Queen City Farms Vertical Barrier Wall System

**VERTICAL BARRIER WALL DESIGN
PROJECT CLOSURE REPORT**

**QUEEN CITY FARMS SUPERFUND SITE
MAPLE VALLEY, WASHINGTON**

APPENDIX B DESIGN AND SPECIFICATION MODIFICATIONS

TYPICAL COVER SYSTEM SECTION WITH GCL 9
SCALE: NONE C-11A

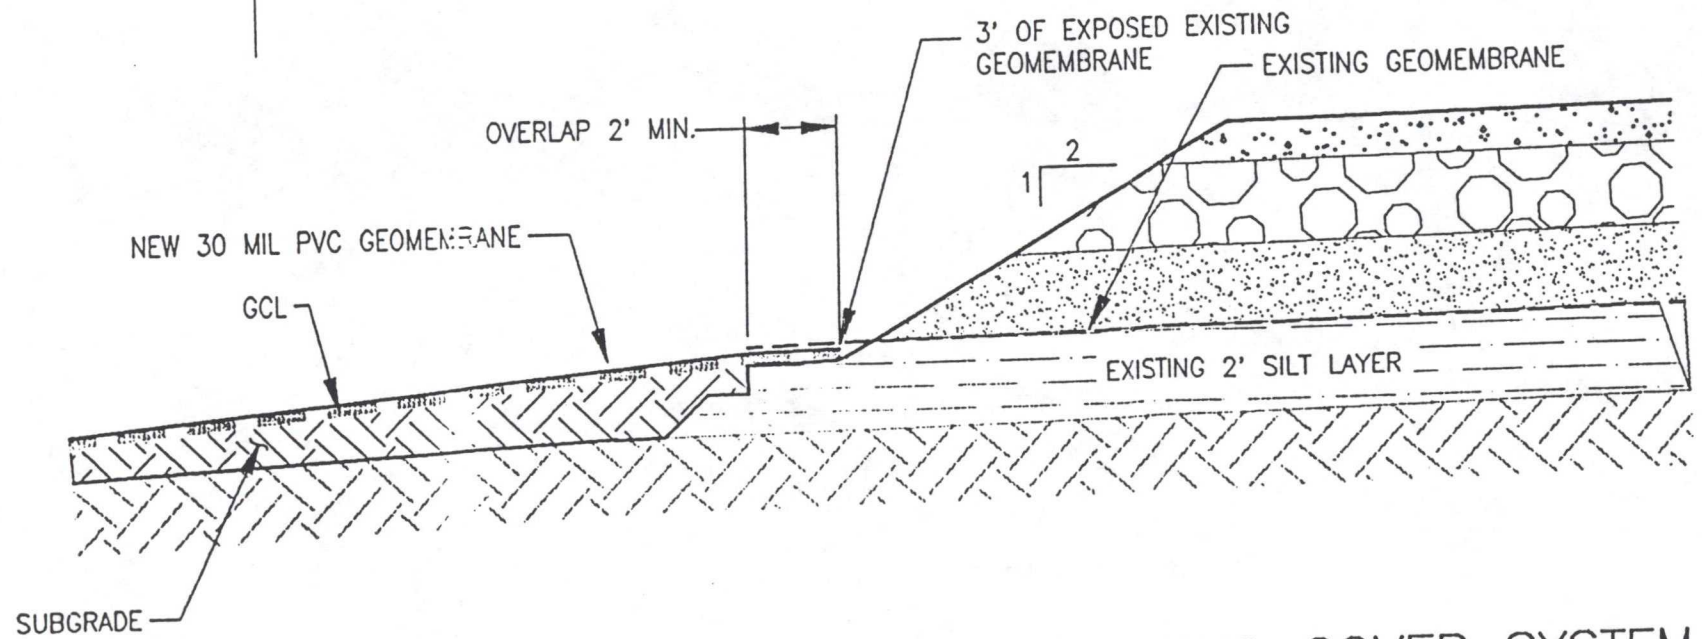
MODIFICATION MADE: Substitute geosynthetic clay liner (GCL) for silt in expanded cover system. Add new TRD Specification Section 02919 and "cover system with GCL" details.

REMARKS: *Add the following to 3.04(1.) If the GCL must be installed during periods of precipitation, protect the GCL roll and top of newly installed GCL from precipitation to avoid bentonite hydration. If the GCL is hydrated when no confining stress is present, remove and replace the hydrated material.
ATTACHMENTS: New TRD Specification Section 02919 and new cover details with GCL.

LOCATION/REFERENCE OF MODIFICATION: (1) Final Grading and Drainage Plan,
Dwg C-9, and (2) Detail for Clean-Outs C-10

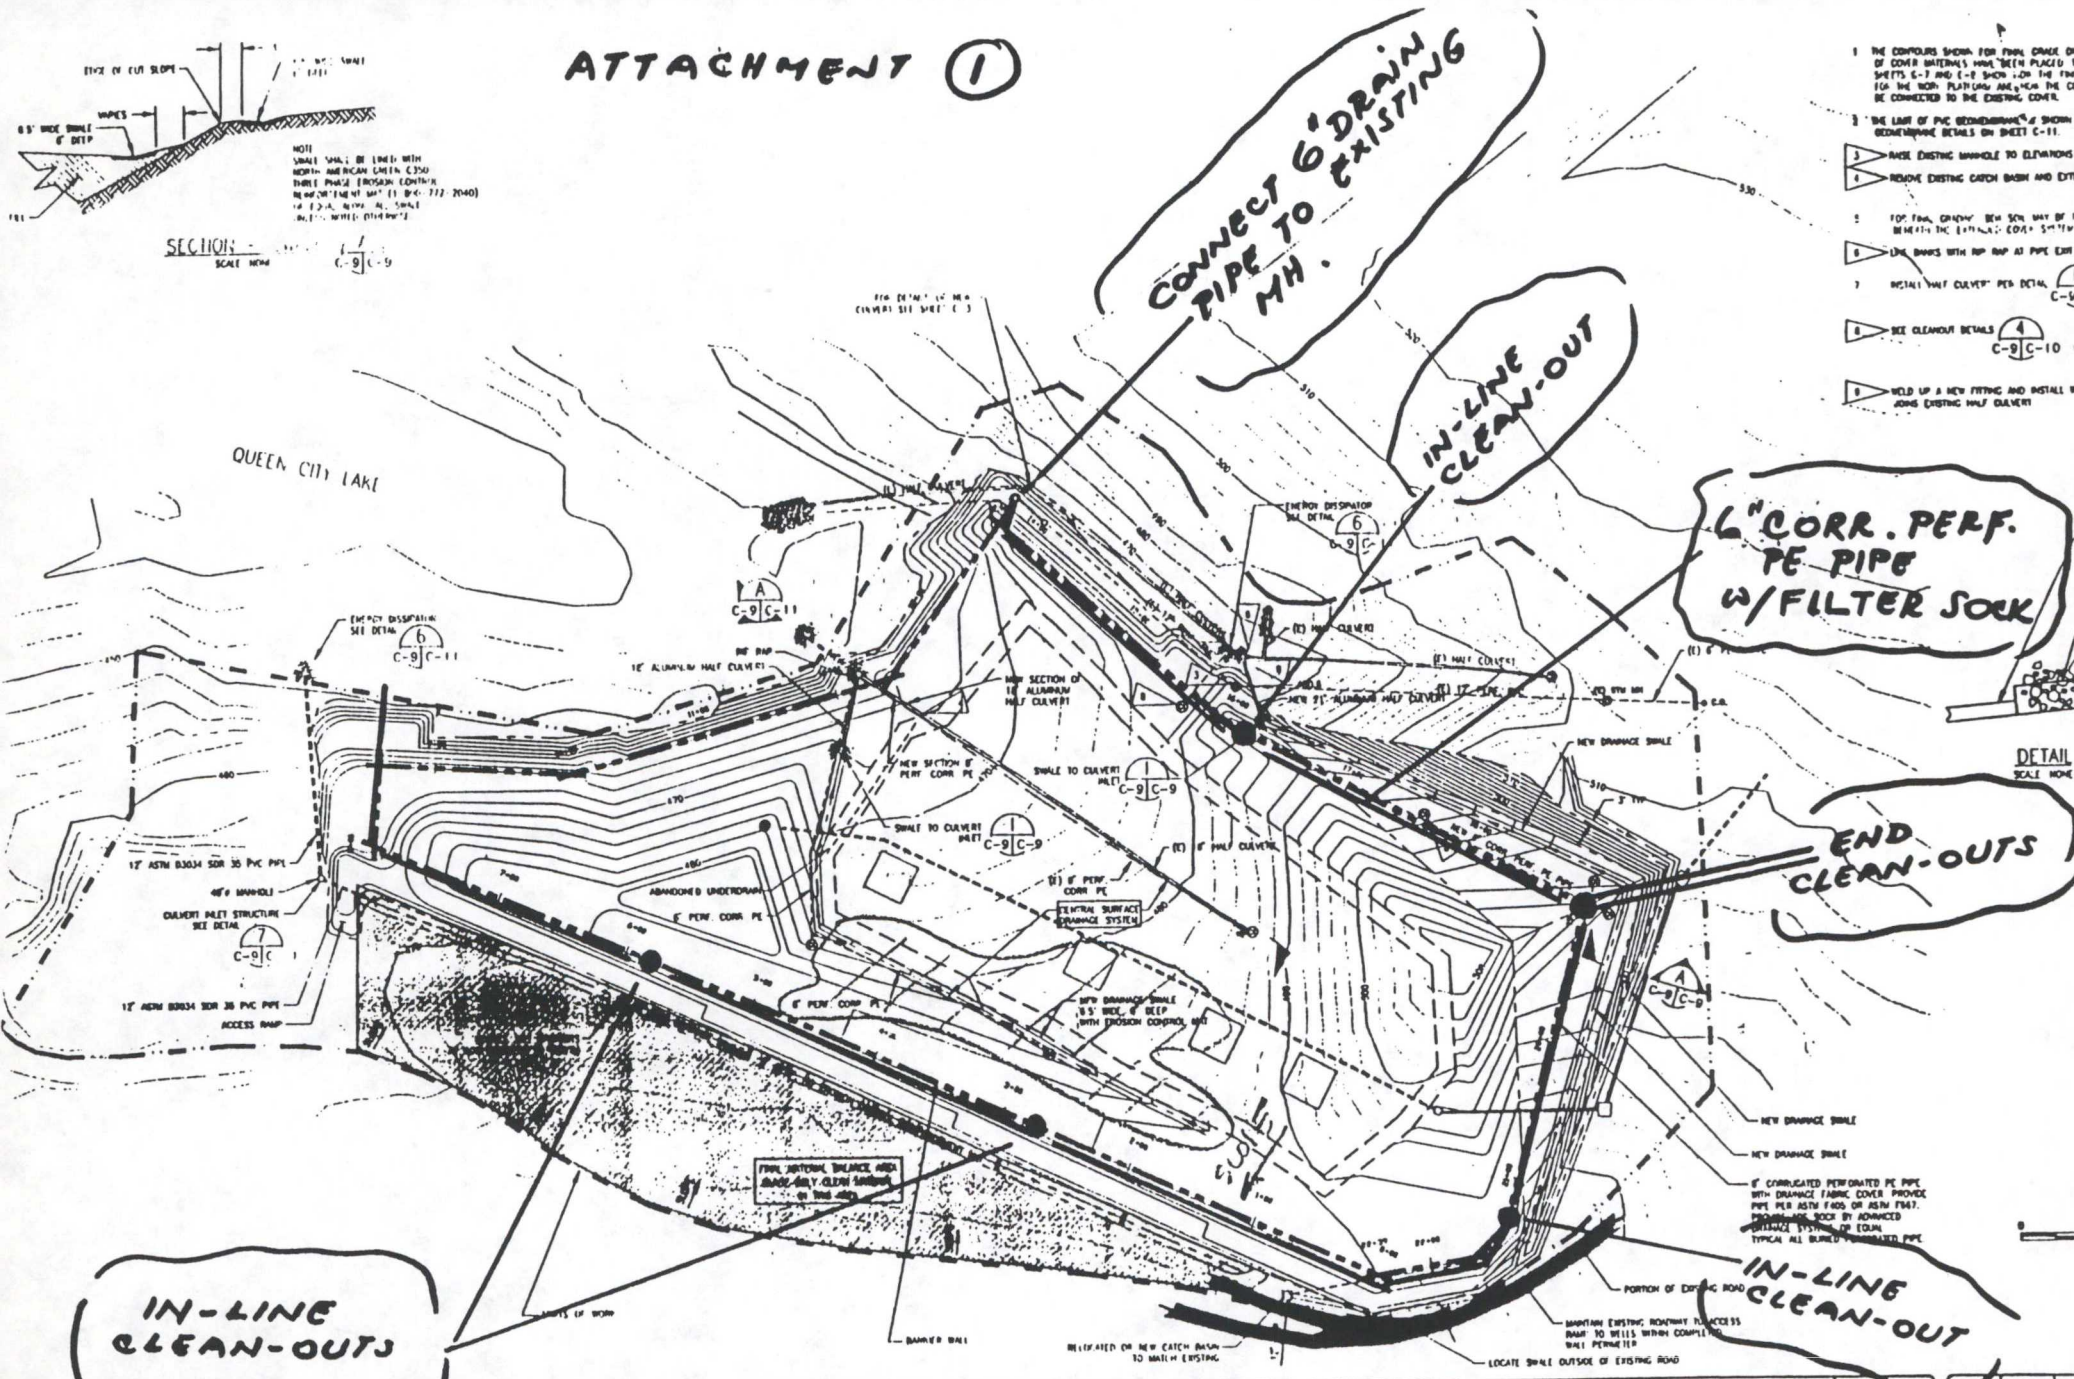
MODIFICATION MADE: Modify locations of clean-outs for 6-inch drain pipe; extend pipe as
shown on attachment; backfill PVC clean-outs with compacted dry-mix (Sakrete)

SLOPE ALONG QC LAKE EROSION CONTROL

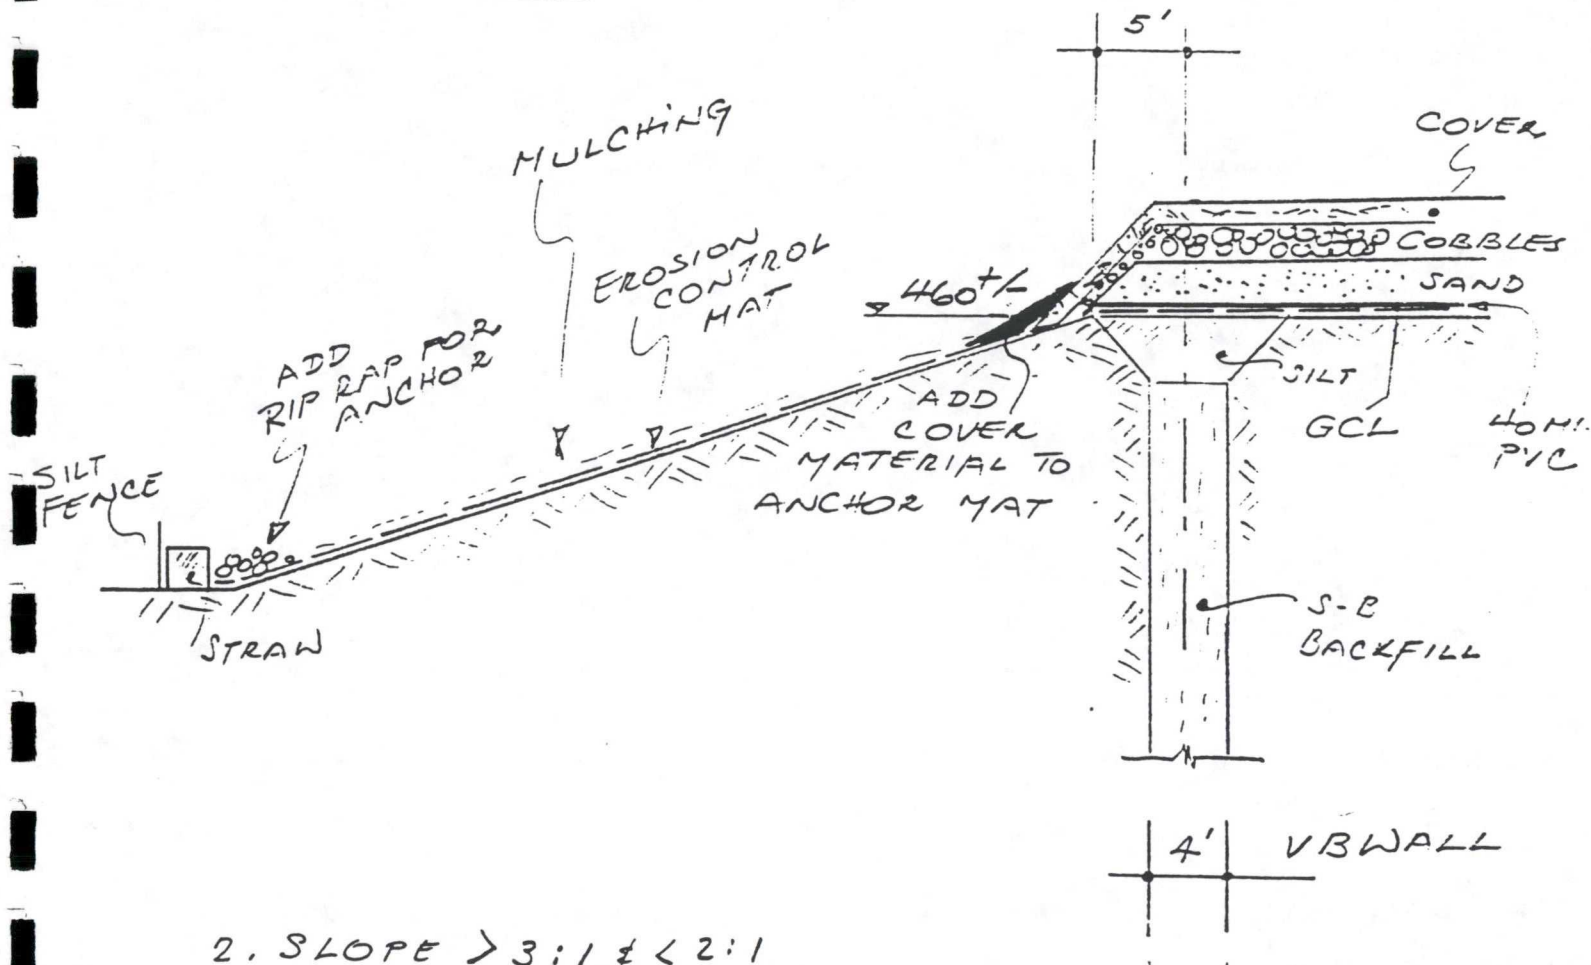
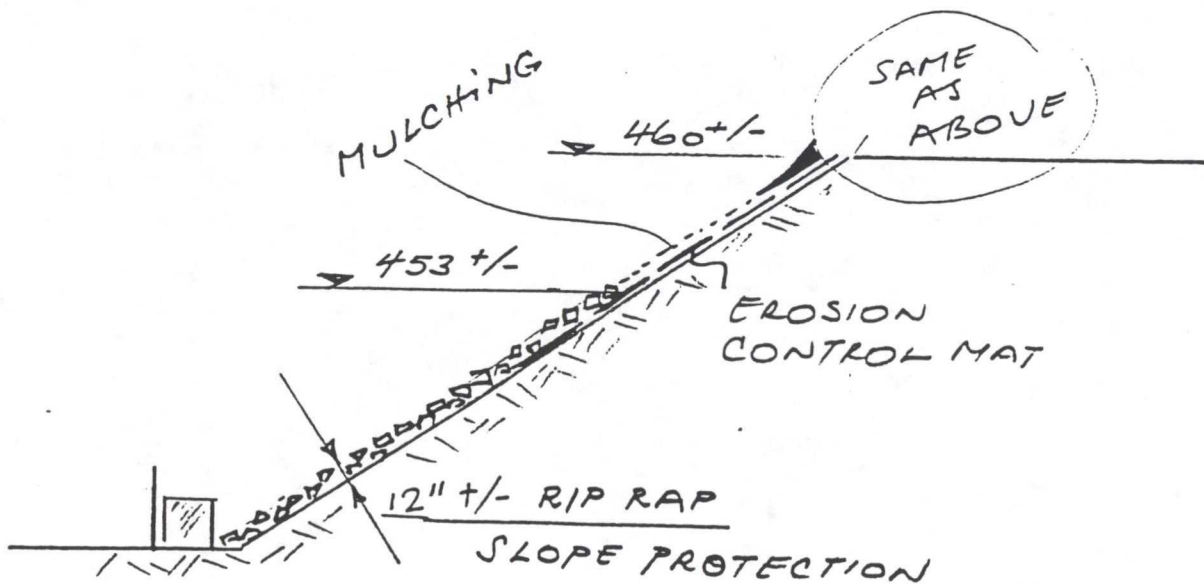
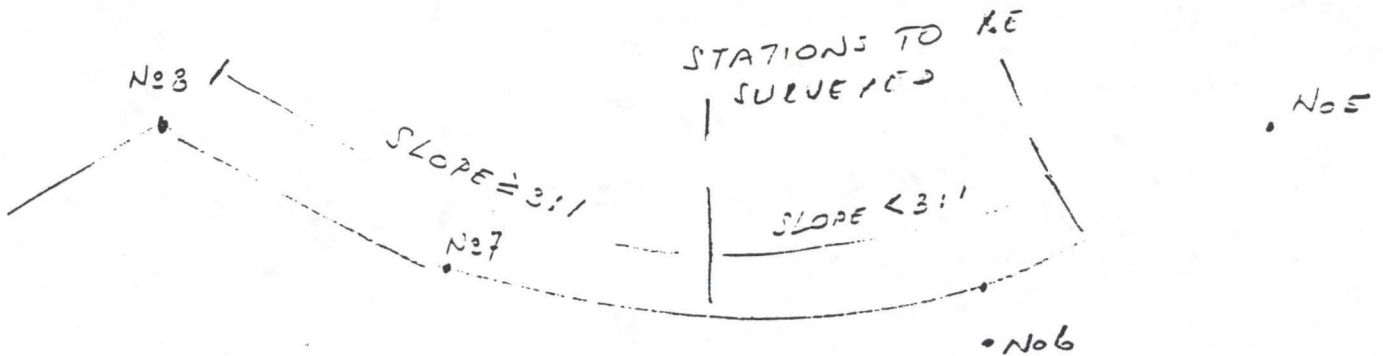
Due to concerns regarding the erosion potential of the embankment between the barrier wall and Queen City Lake from station 13+79 to 8+60, enhanced erosion control measures were specified. Rip rap was placed from the toe of the slope to approximately halfway up the slope. Erosion control mat and mulch were placed along the top half of the slope (see Modification Number 8, Appendix B).

AS BUILT CLEANOUT DETAILS

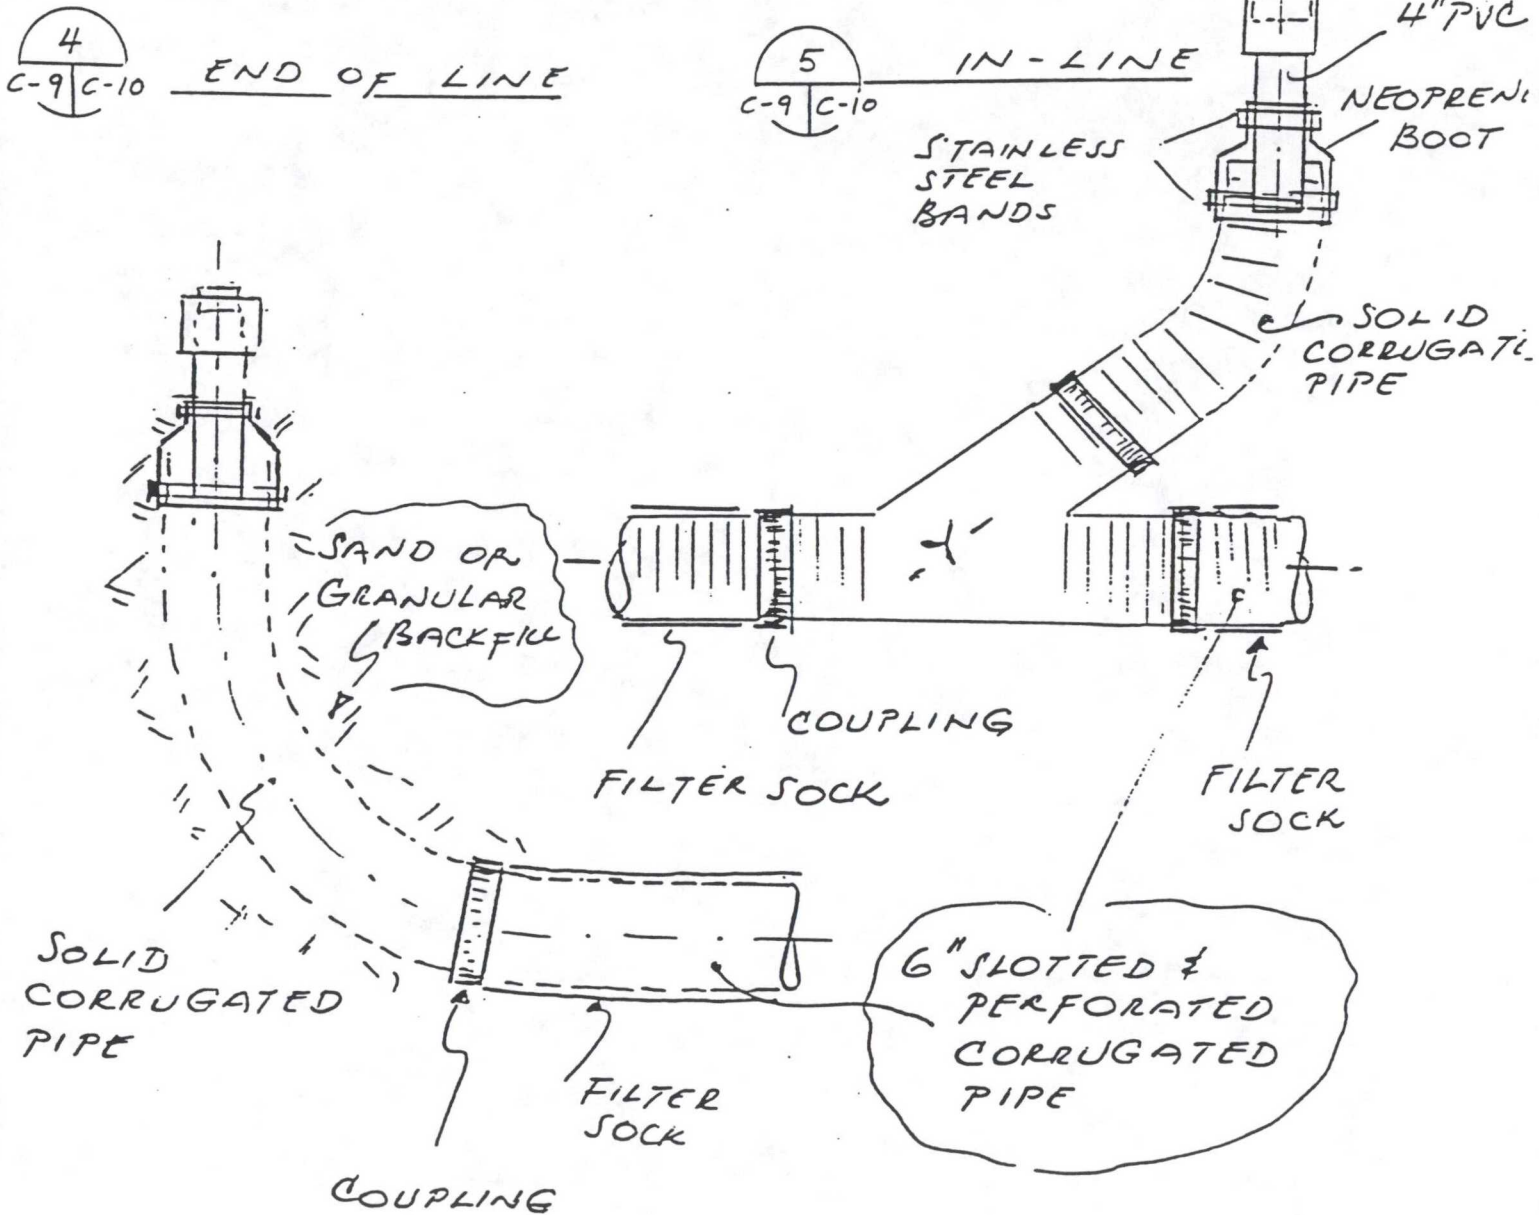
MODIFICATION MADE: Modify cleanout details shown on Sheet C-10 to conform to those shown on Attachment 1.

NOTE: PROVIDE CAST IRON RINGS AND COVERS
AS SHOWN ON SHEET C-10.
